City of Port Phillip
Advertised Plan 1 of 40

28-32 ALBERT ROAD, SOUTH MELBOURNE
DRAWING LIST

AMENDMENTS TO ENDORSEMENT PLANS:

Project Title
28-32 ALBERT ROAD
SOUTH MELBOURNE

Drawing Title
GENERAL ARRANGEMENT PLAN
LEVEL 15 - LEVEL 20

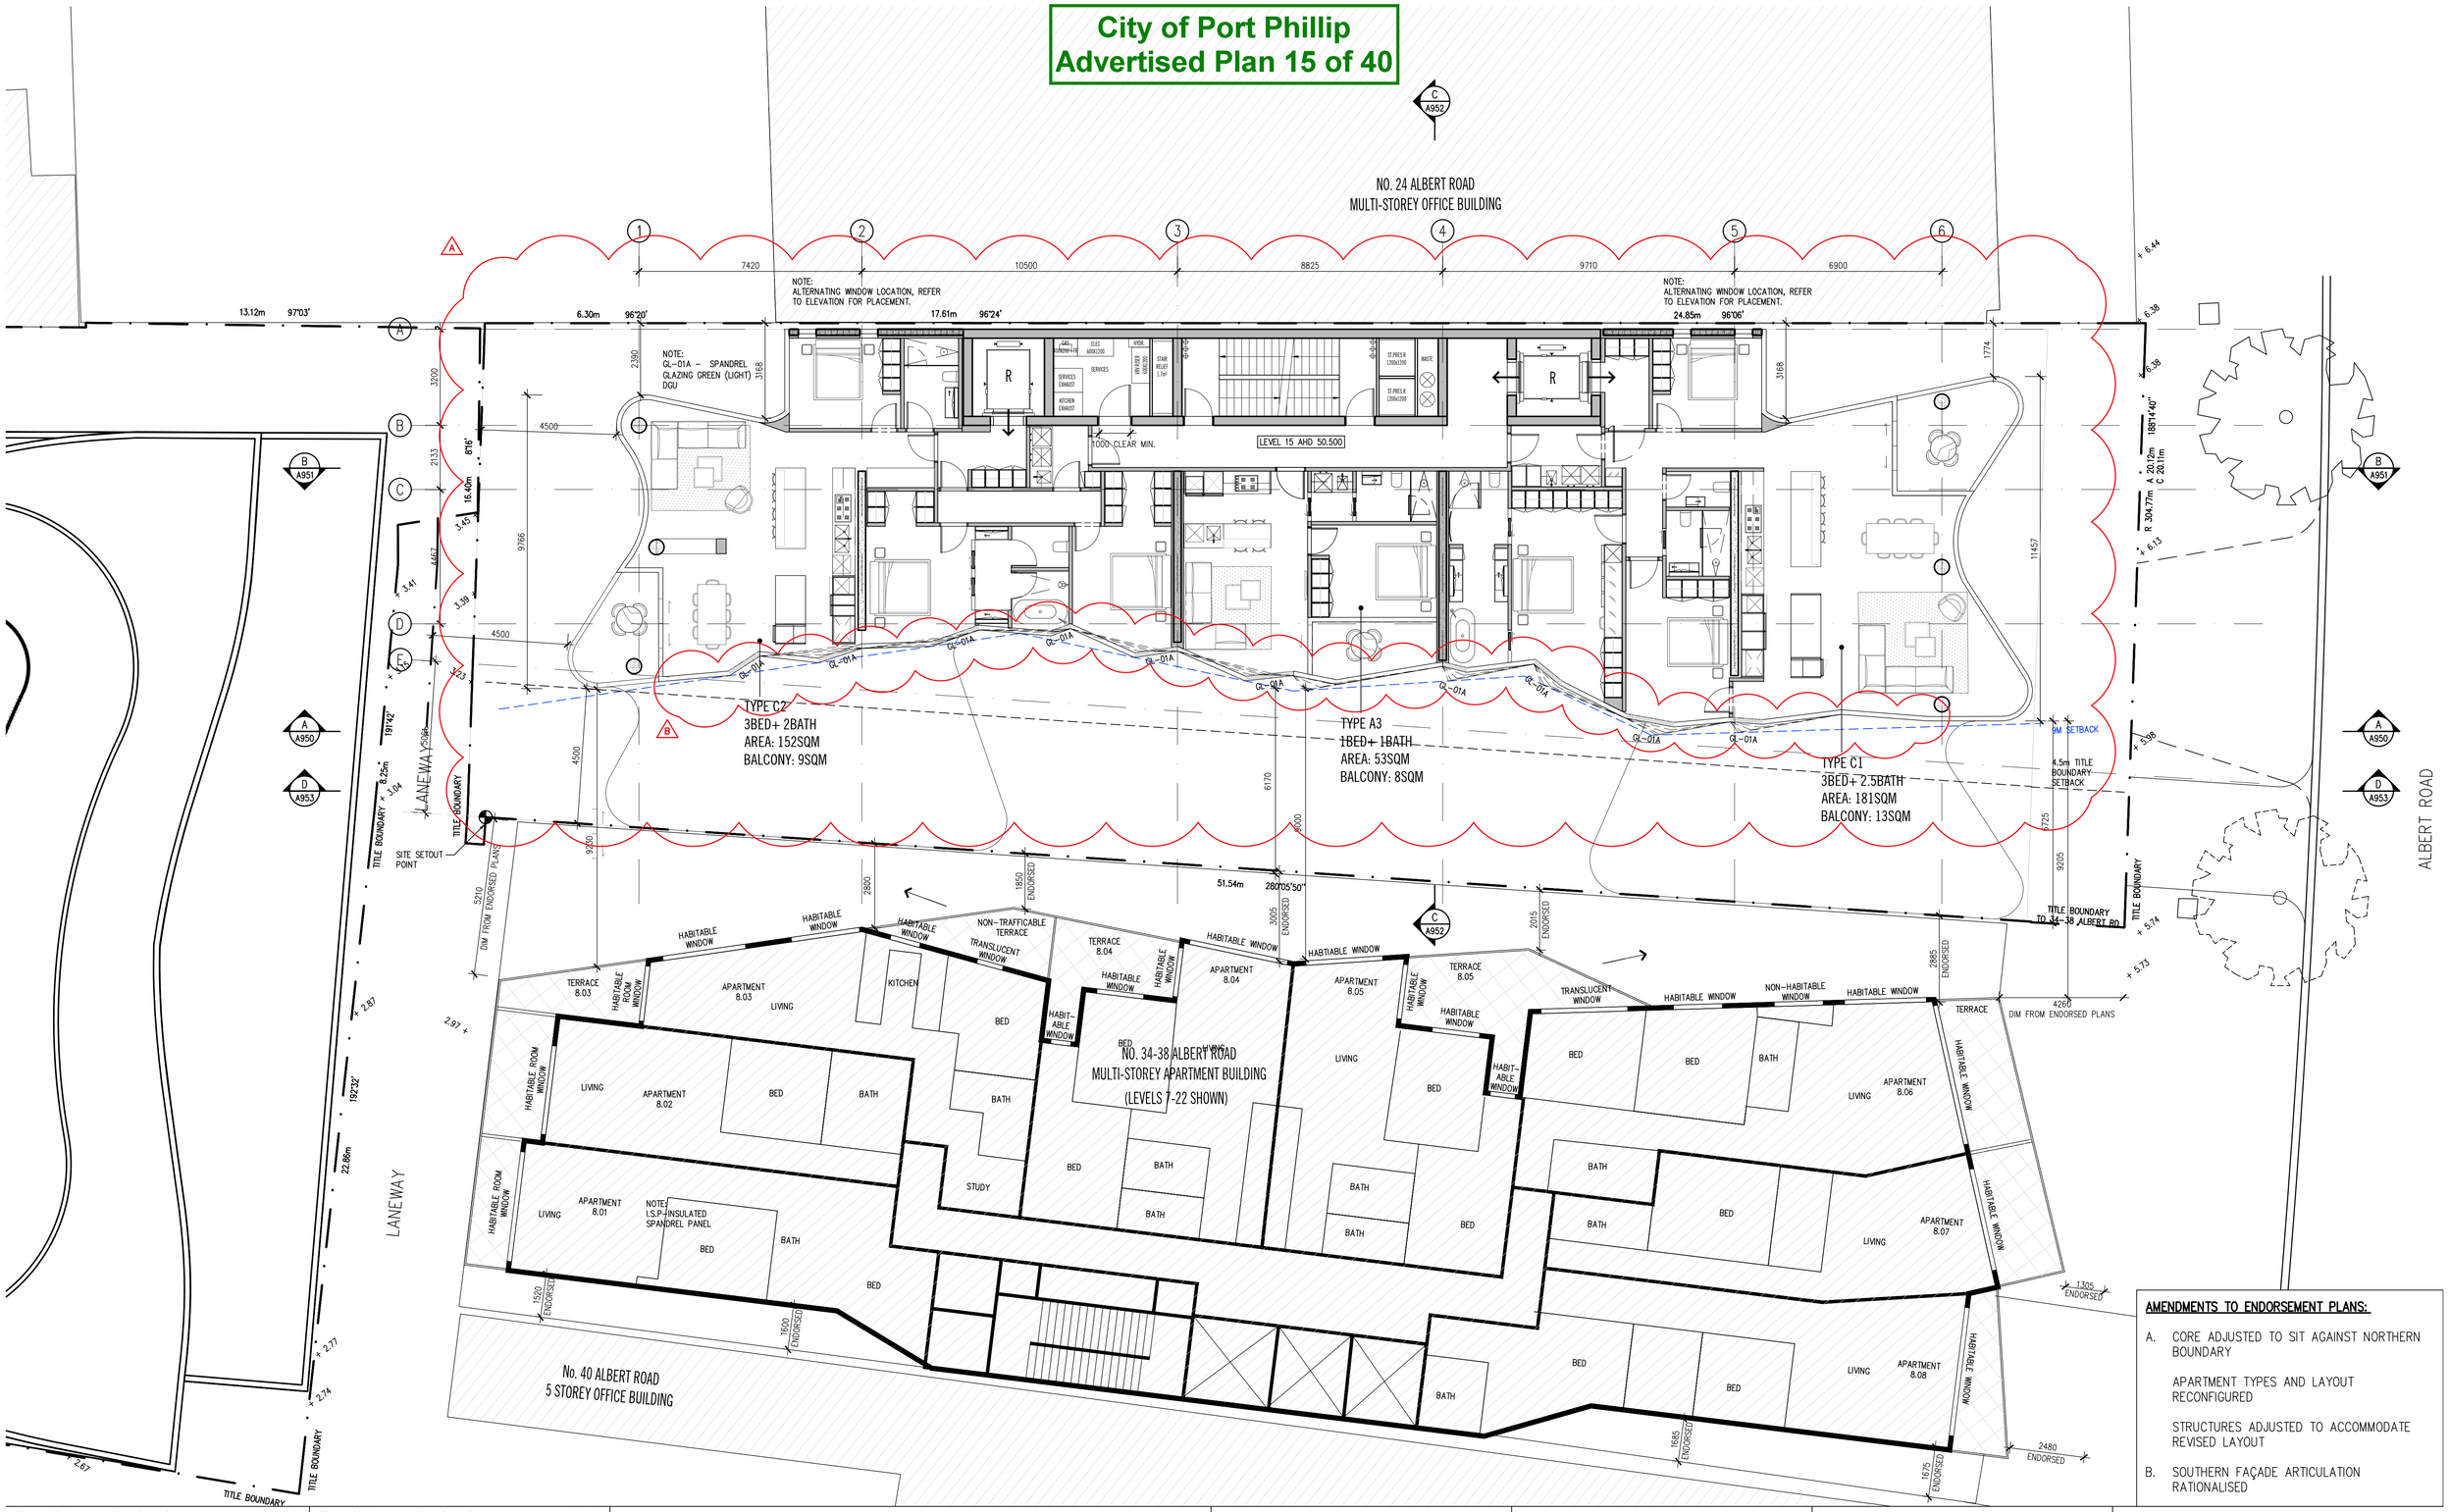
A. CORE ADJUSTED TO SIT AGAINST NORTHERN BOUNDARY

STRUCTURES ADJUSTED TO ACCOMMODATE REVISED LAYOUT

Drawing Title
GENERAL ARRANGEMENT PLAN
LEVEL 21-22

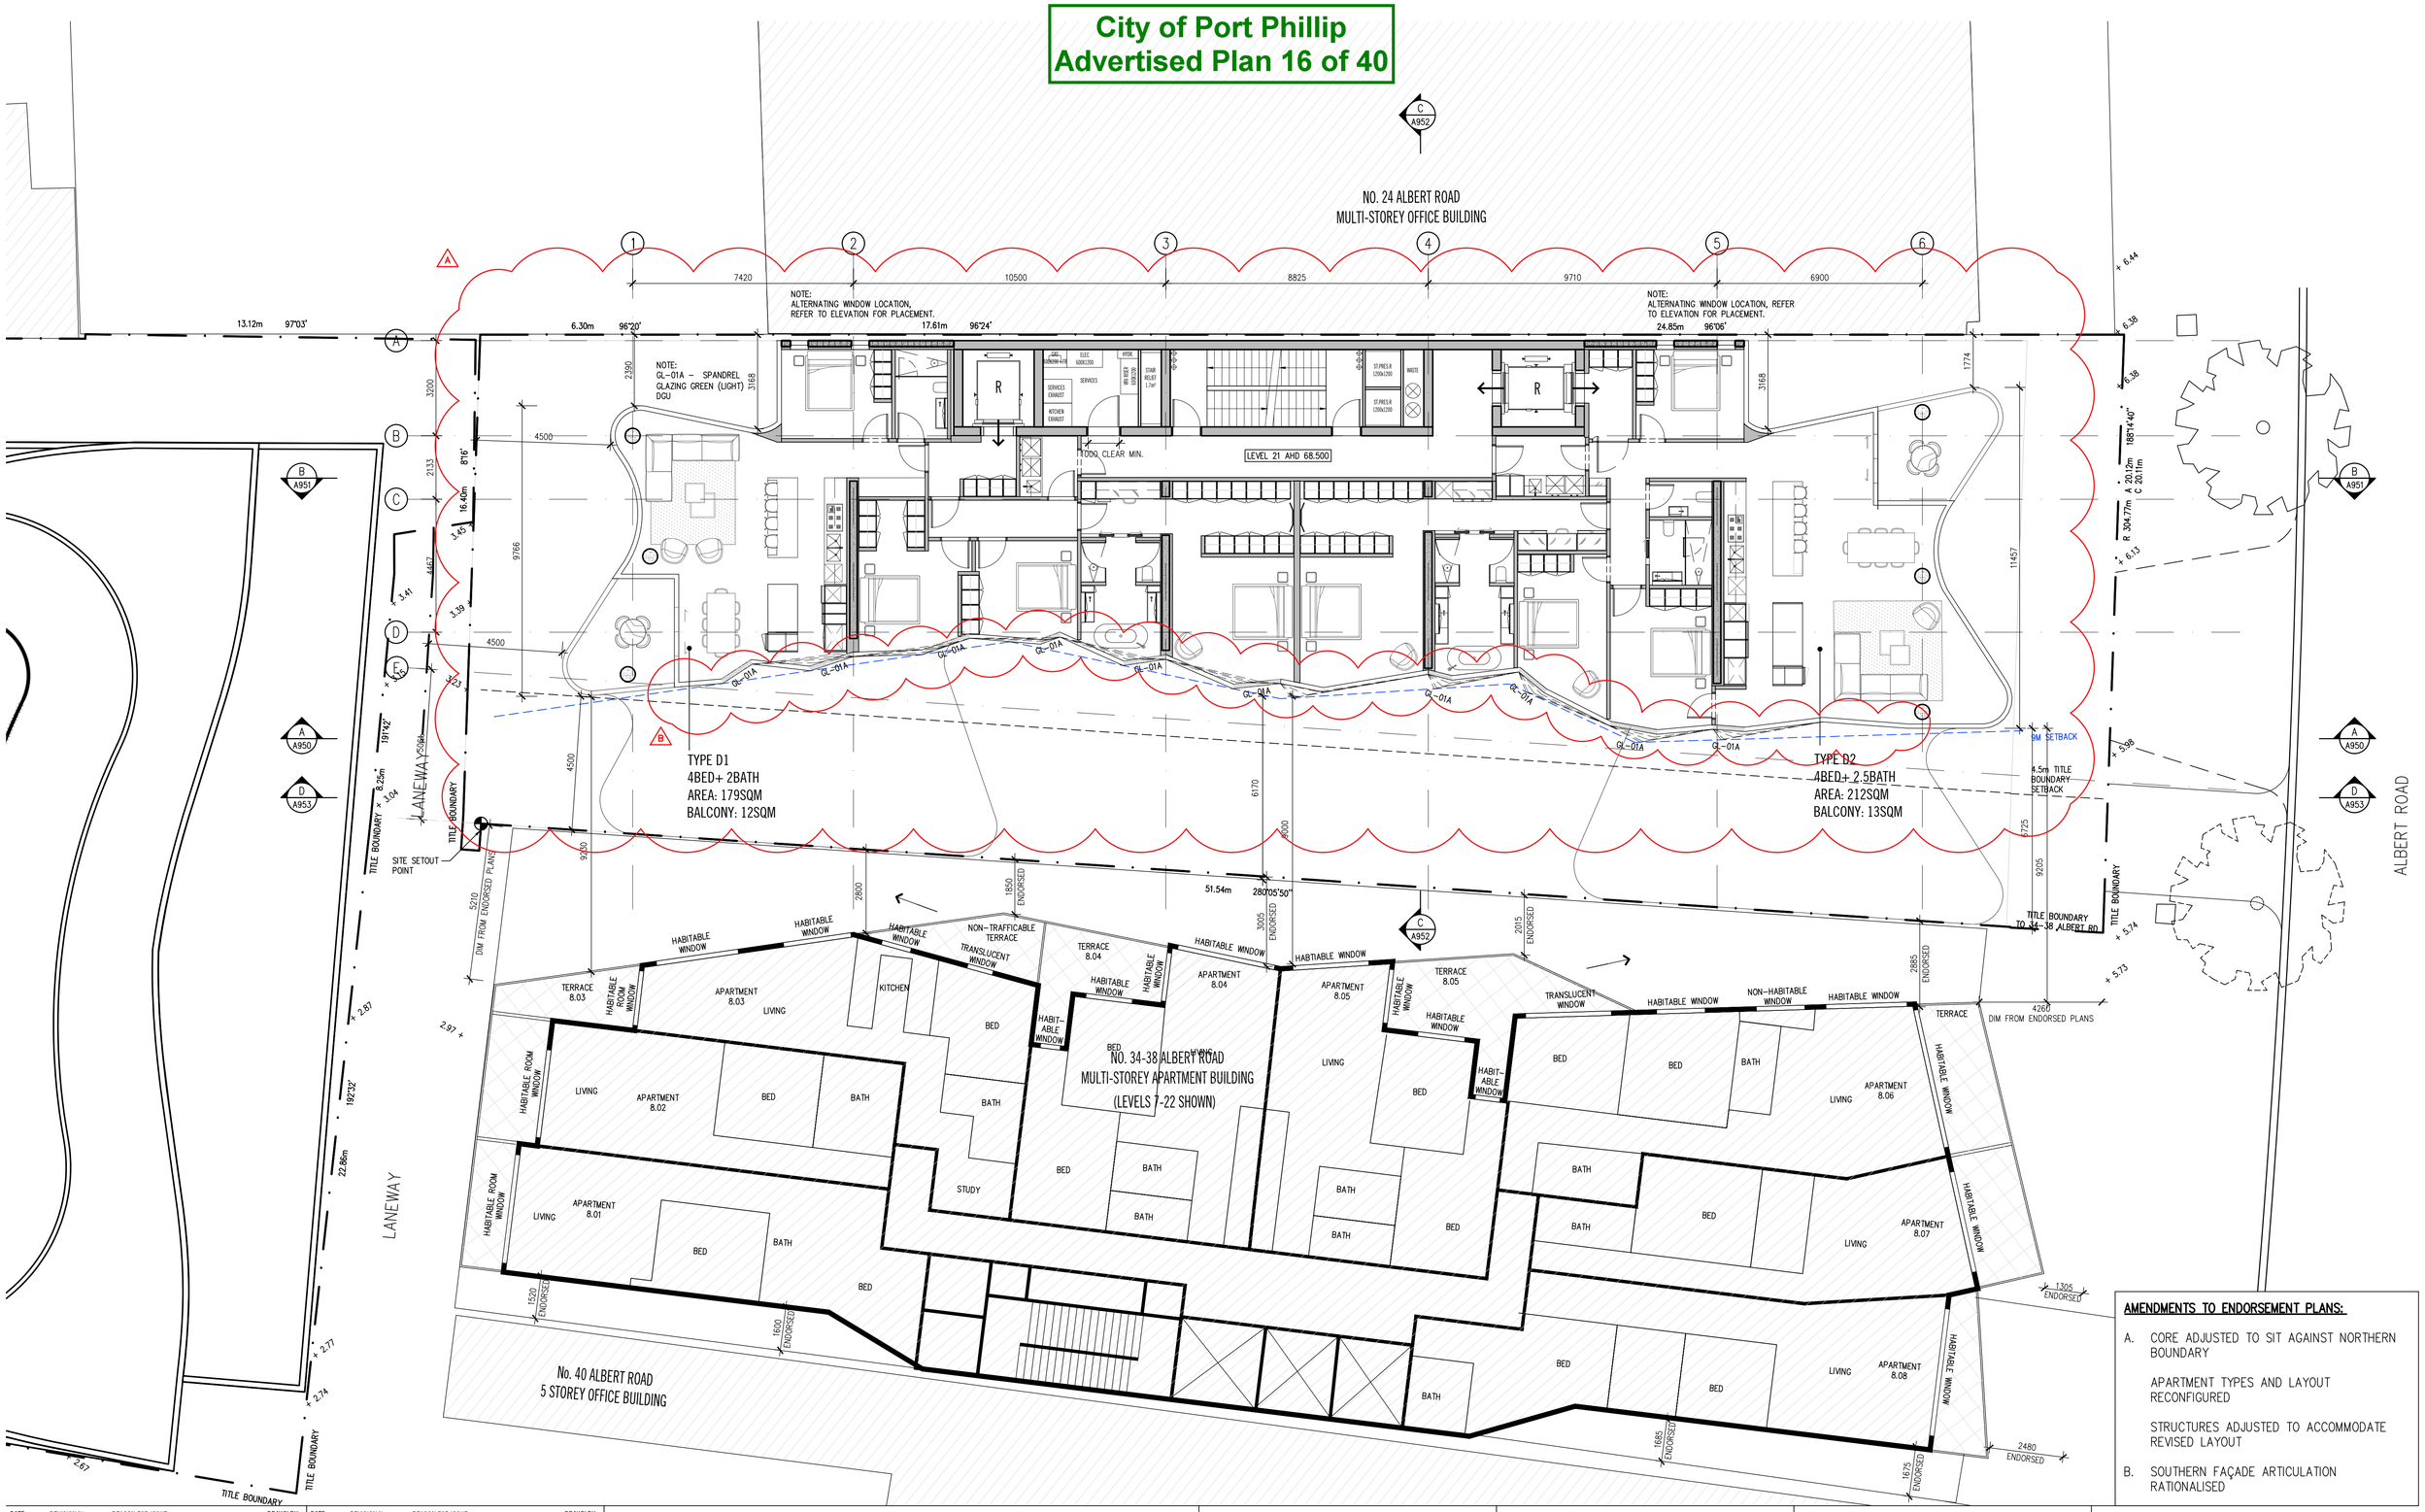
A. CORE ADJUSTED TO SIT AGAINST NORTHERN BOUNDARY

STRUCTURES ADJUSTED TO ACCOMMODATE REVISED LAYOUT

Drawing Title
GENERAL ARRANGEMENT PLAN
LEVEL 23

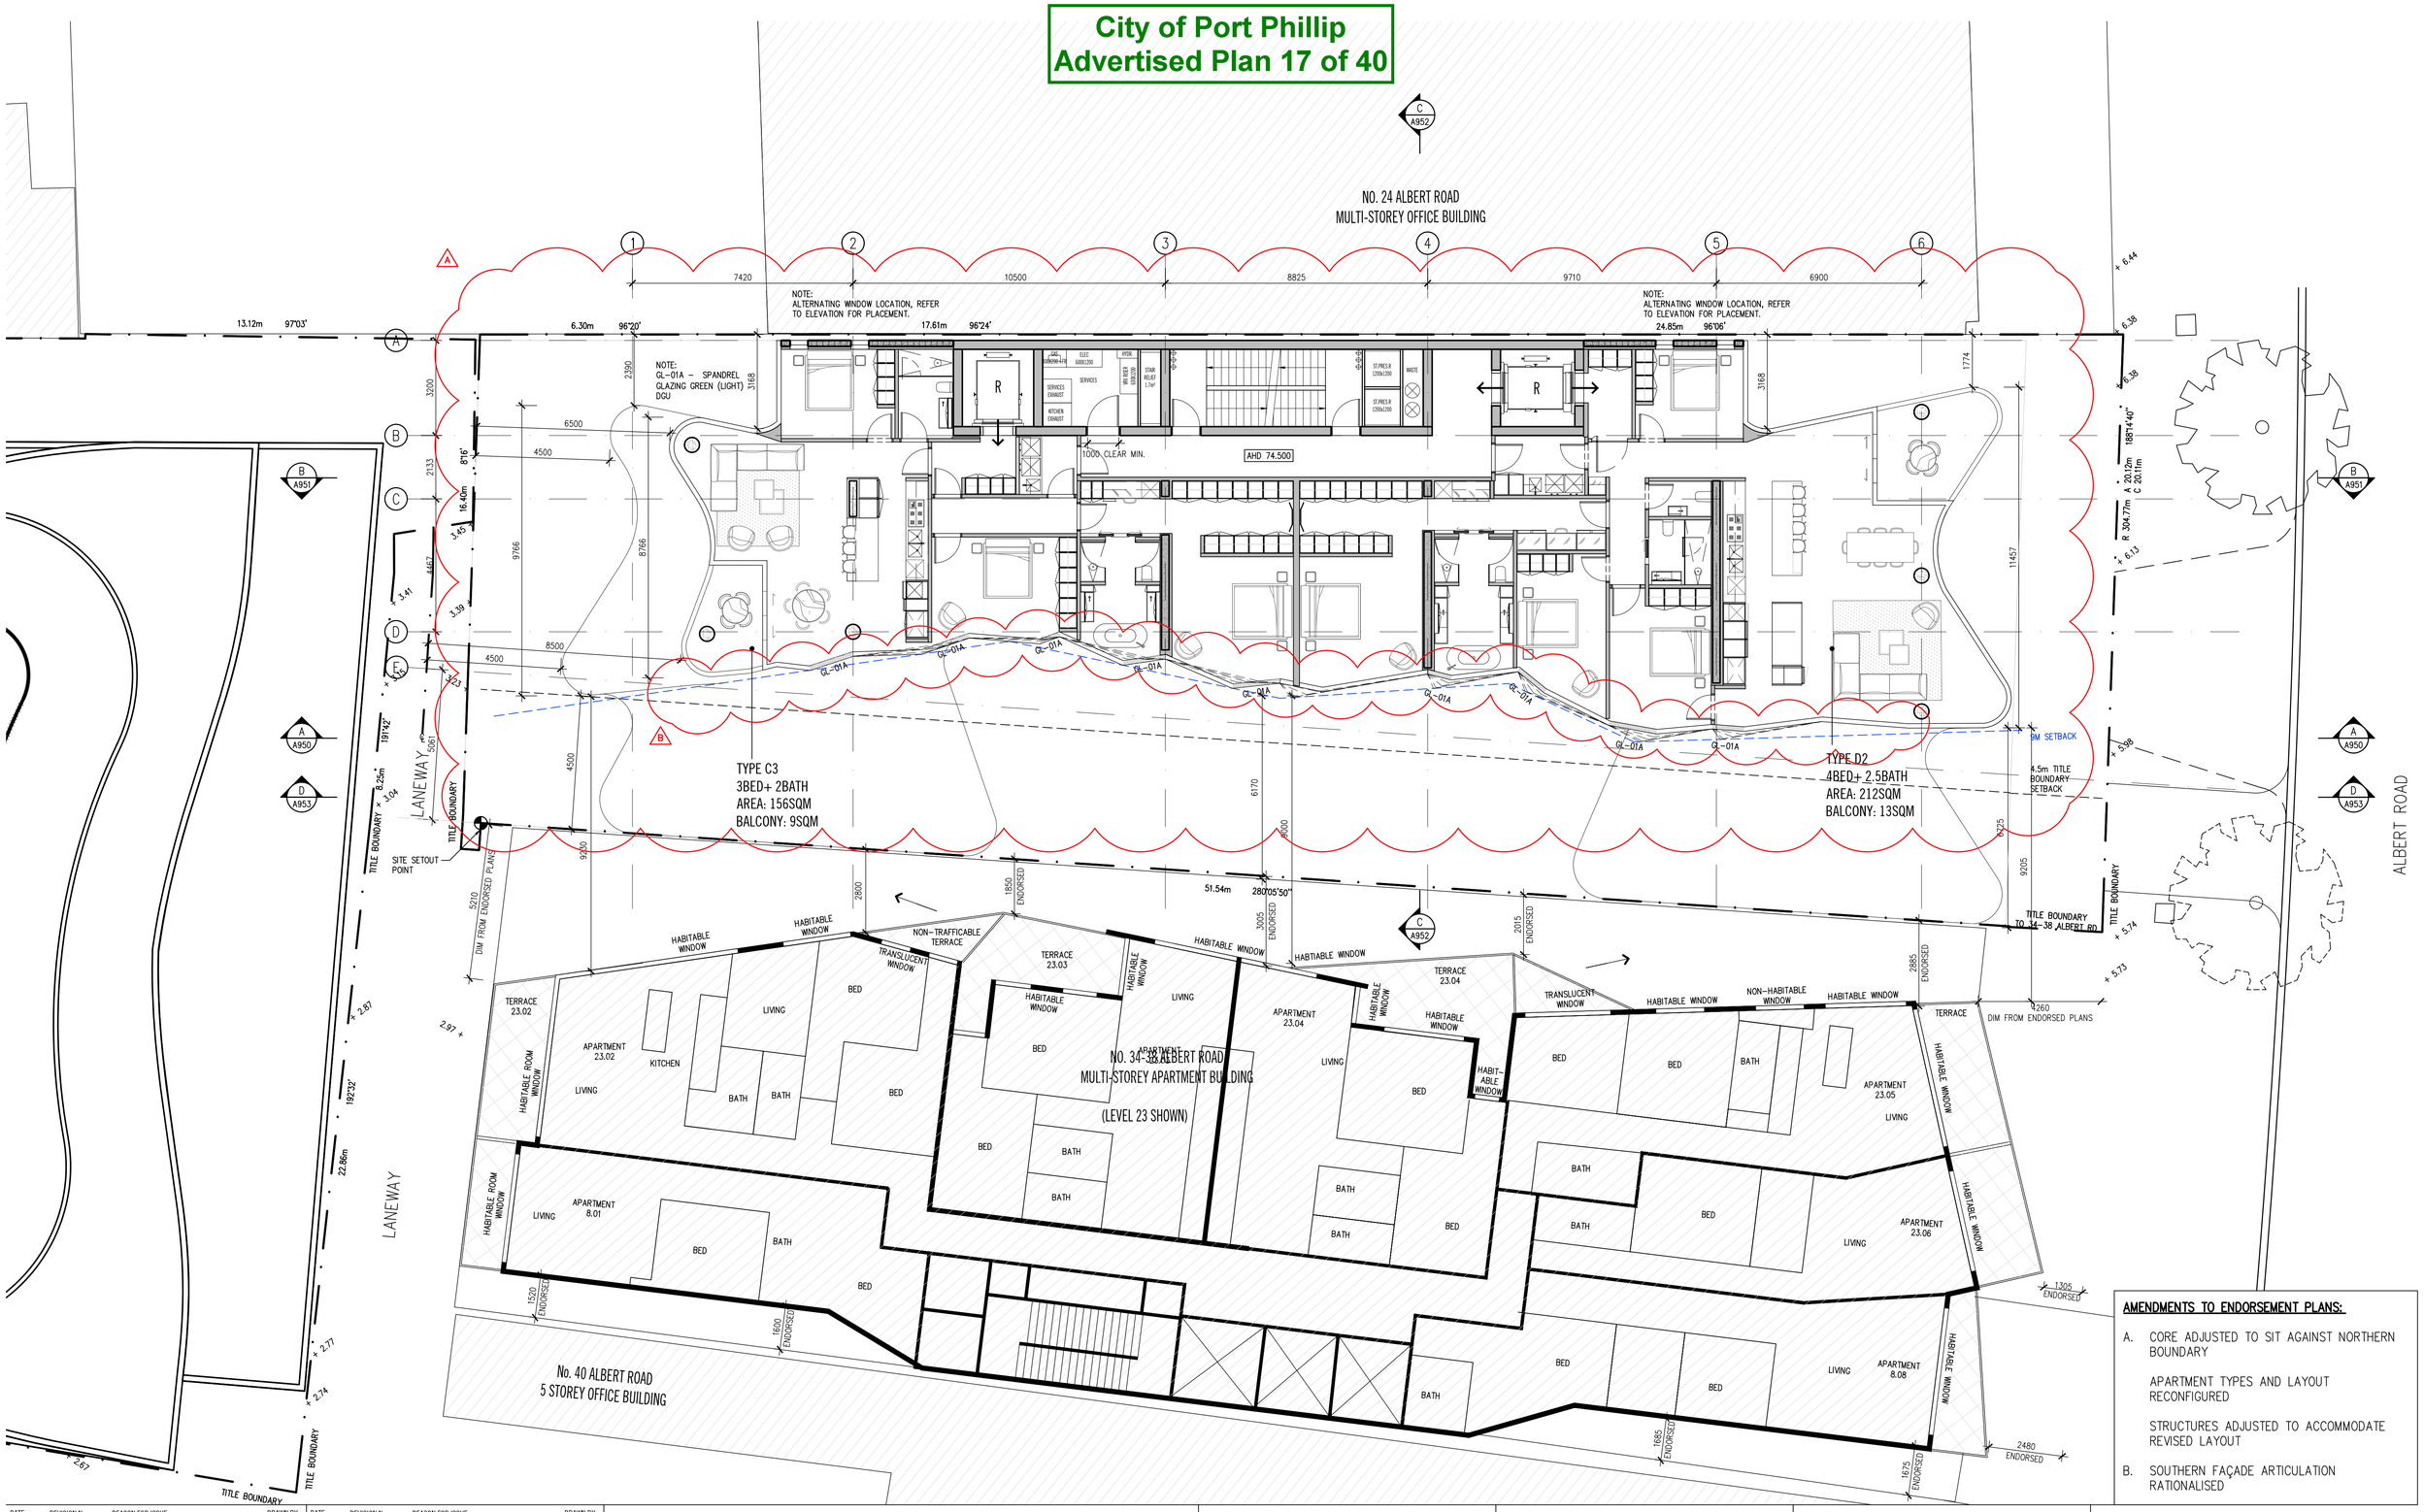
A. CORE ADJUSTED TO SIT AGAINST NORTHERN BOUNDARY

STRUCTURES ADJUSTED TO ACCOMMODATE REVISED LAYOUT
